CITY OF VISALIA
HISTORIC PRESERVATION ADVISORY COMMITTEE
Wednesday, April 9, 2025, at 5:30PM

SUBJECT: **Historic Preservation Advisory Committee Item No. 2025-05:** A request by Kevin Fistolera to replace 48 windows on a single-family residence located in the DMU (Downtown Mixed Use) Zone. The project site is located at 410 North Court Street (APN: 094-271-006).

SUBJECT: Historic Preservation Advisory Committee Item No. 2025-06: A request by Bruce McMahon to remodel an accessory dwelling unit in the R-1-5 (Single Family Residential, 5,000 square foot minimum site area) Zone. The project site is located at 808 and 808 ½ West Myrtle Avenue (APN: 096-151-009).

EXISTING WINDOWS

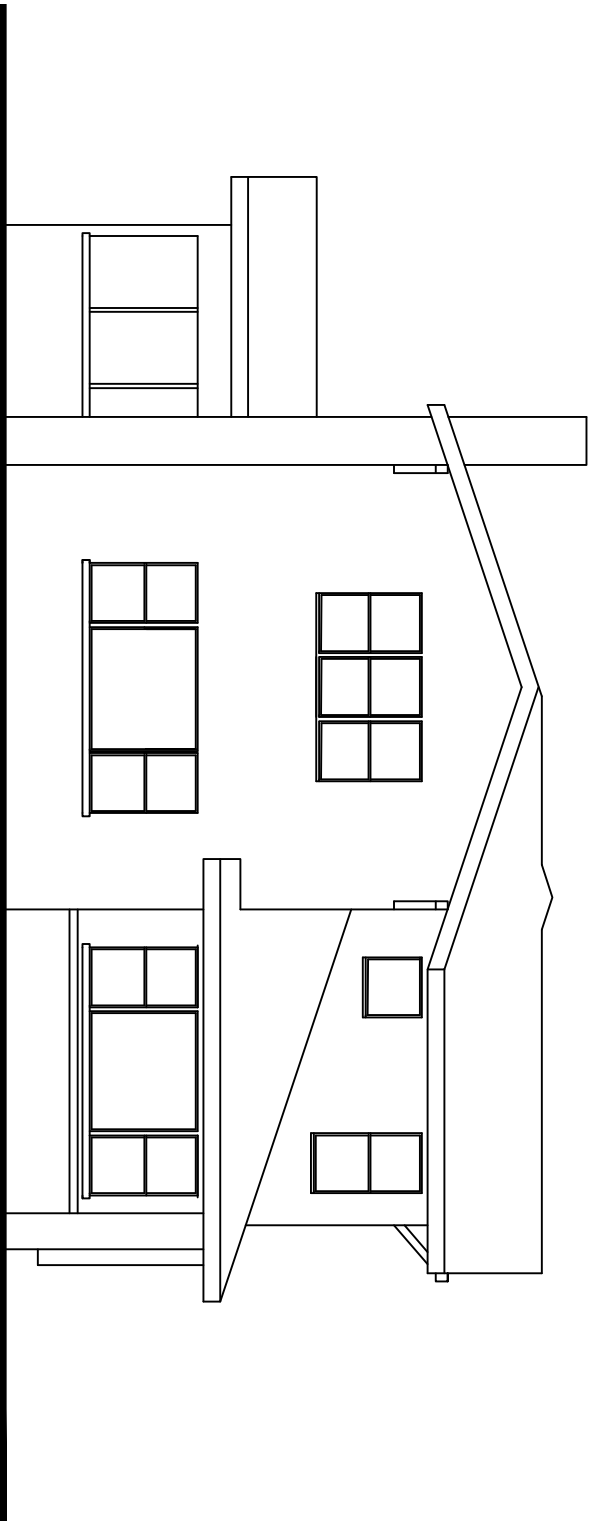
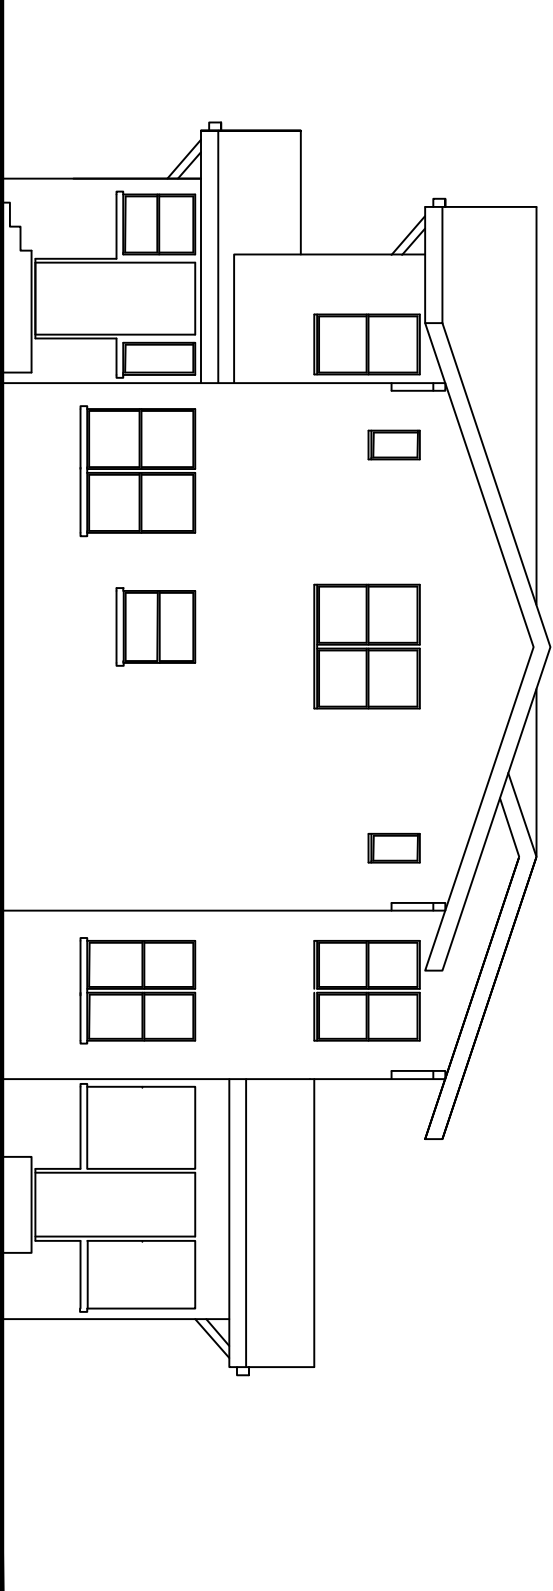
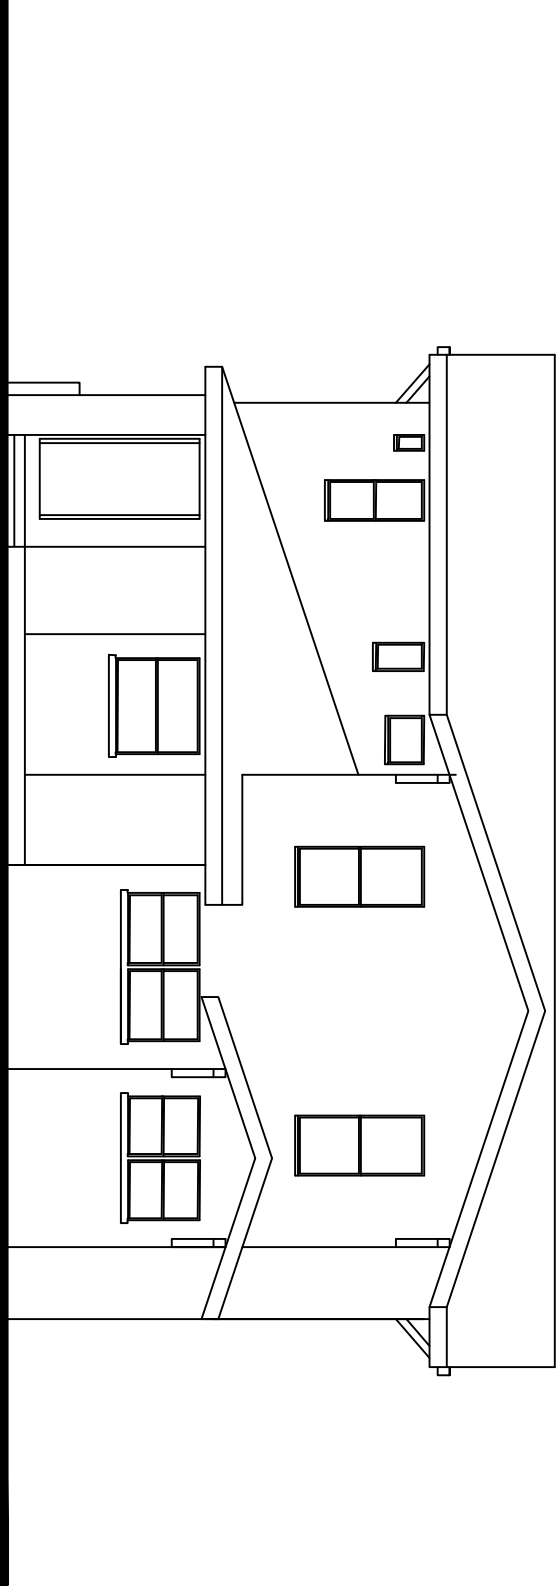
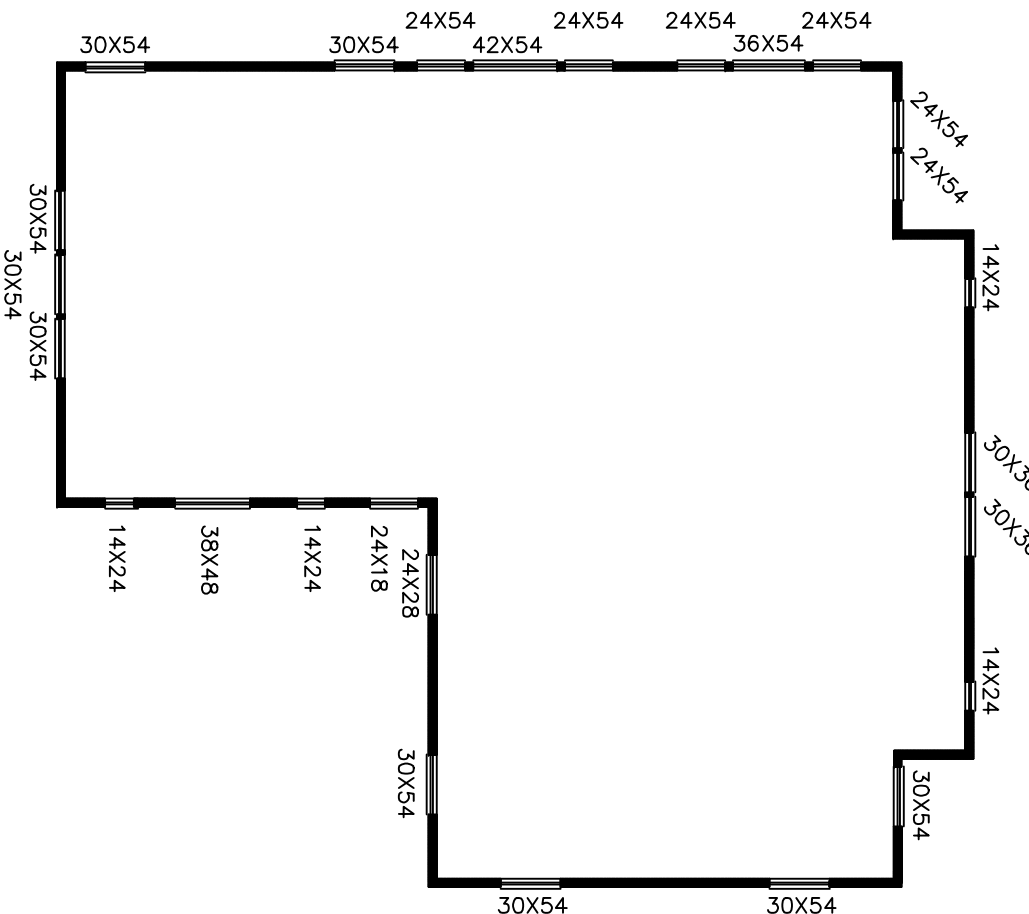
Due to their design, variety, and placement, the windows are considered a distinguishing feature of the building. If they are to be replaced, the applicant must demonstrate that replacement is necessary, and that the replacement materials match the original in "...composition, design, color, texture, and other visual qualities."

In this instance, the applicant has submitted evidence that the windows are in disrepair (see site pictures in Exhibit "B"). Staff also concluded a site visit on April 4, 2025, and determined that the windows show significant damage, including rotted wood frames and broken glass panes.

The proposed window replacement would maintain the building's original character. Features such as window trim and sills would remain. New windows and wood screens will be conditioned to maintain the same features as the original windows, such as their operating mechanism and style, mullion patterns and spacing, frame dimensions and profiles, and sightlines and proportions (see Condition No. 2). The applicant will also rebuild wood window screens for use on the building (Condition No. 3). These rebuilt screens will match the original screens and will help maintain the building's original character. With the application of these conditions, the proposal will preserve the overall historical integrity of the structure.

2. That the new windows shall match the features of the original windows, including operating mechanism and style, mullion patterns and spacing, frame dimensions and profiles, and sightlines and proportions. That the project undergoes the appropriate City permitting process for exterior alterations on the project site.

3. That the applicant shall rebuild and install wood window screens for all the windows that can support window screens. The window screens shall retain an appearance consistent with the original window screens depicted in Exhibit "A",

SOUTH ELEVATION FRONT

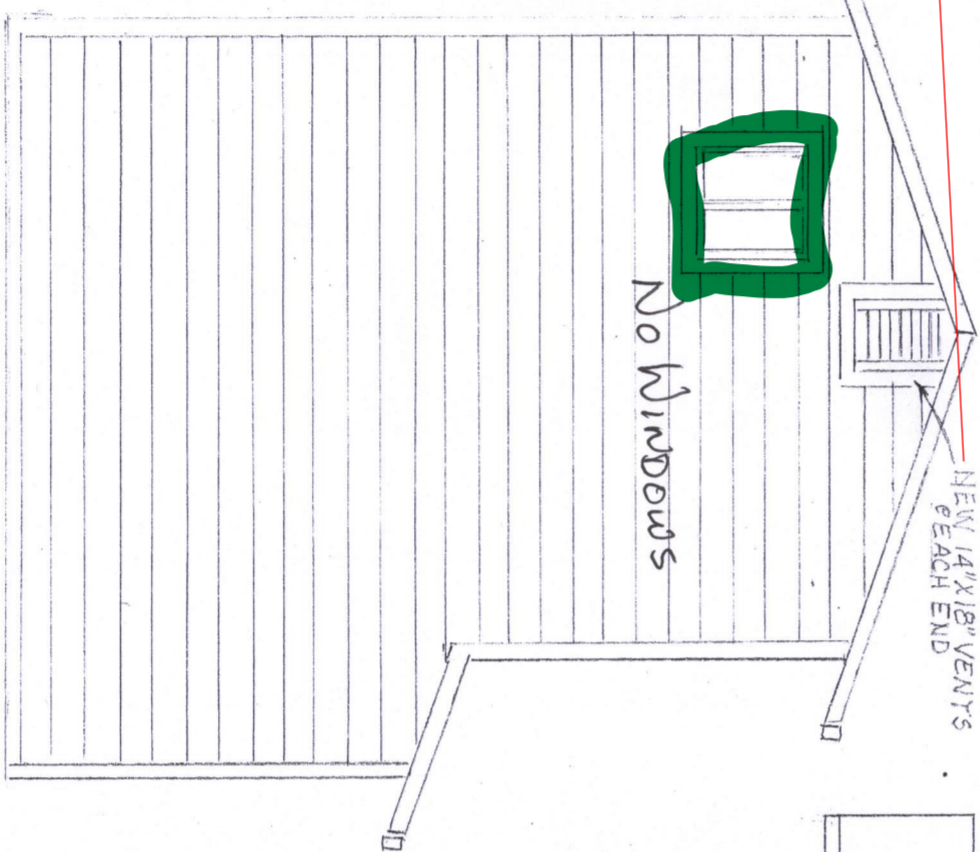
Only work proposed to the windows and gable vents have potential to be detrimental to the exterior. In particular the southern building elevation, which can be viewed from West Myrtle Avenue, contains original windows and gable vents that match those of surrounding craftsman buildings in the neighborhood. Alteration of the features would have the potential to

decrease compatibility with the streetscape, and would eliminate two of the structures few original elements.

Condition No 1.a – That the original window openings and spacings on the 2nd story of the ADU's southern elevation be maintained.

Condition No. 1.b – That the window on the 1st story of the ADU's southern elevation open vertically.

Condition No. 1.c – That all new windows on the ADU's southern elevation contain trim and sills similar to the original windows.

Condition No. 1.d – That the existing design of the gable vents on the ADU's southern elevation be maintained.
